Site Accessibility Evaluation

Fire Station 12

Accessibility Evaluation

SUBJECT: Fire Station 12 Self-Evaluation

Finding: 1

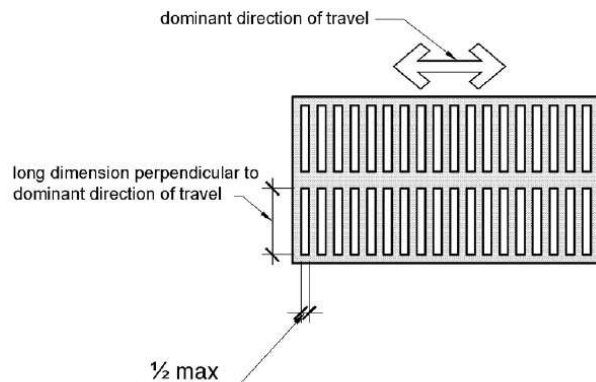
The concrete expansion joint is spaced greater than a 1/2 inch. One joint is 3/4" deep by 2" wide by 11" long. Another joint is 3/4" deep by 2-1/2" wide by 46" long.

The sidewalk has gaps up to 2-1/2" wide and up to 3/4" deep.

Remove and replace the two concrete pads.

Finding: 2

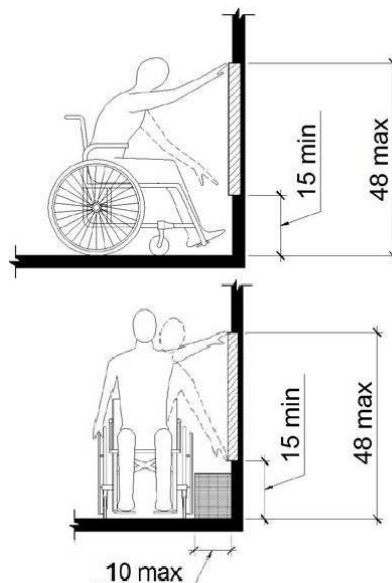
The door bell is not positioned correctly for either a side or front approach.

The door bell is mounted at 54".

Lower the door bell to 48" maximum.

Finding: 3

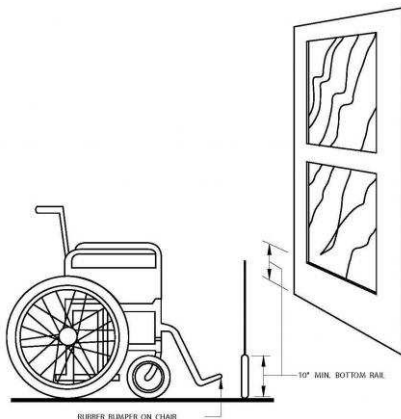
The door has a door stop which prevents it from having a smooth surface at the bottom.

There is a door stop on the entry door.

Remove the door stop.

Finding: 4

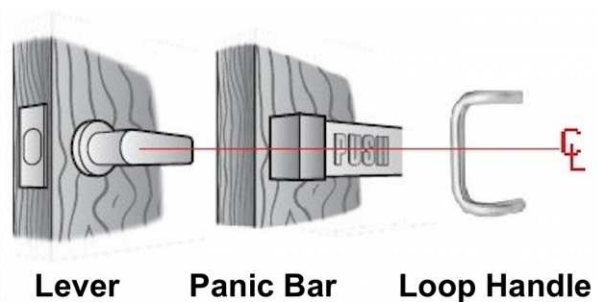
The door/gate operating hardware is not accessible.

The hardware on the entry door is a knob.

Replace with lever style hardware.

Finding: 5

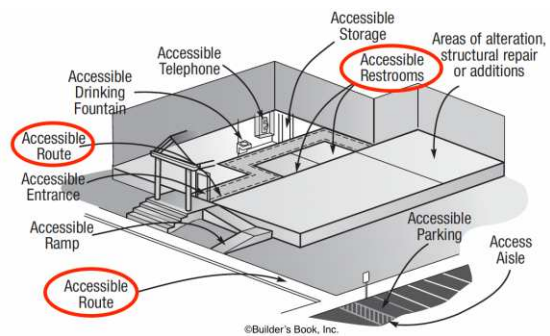
The restroom facilities serving the facility are not on an accessible route and are not accessible. There are multiple issues with them, but they are not intended for public use.

The restrooms are not accessible.

No modifications required if these restrooms are not for public use.
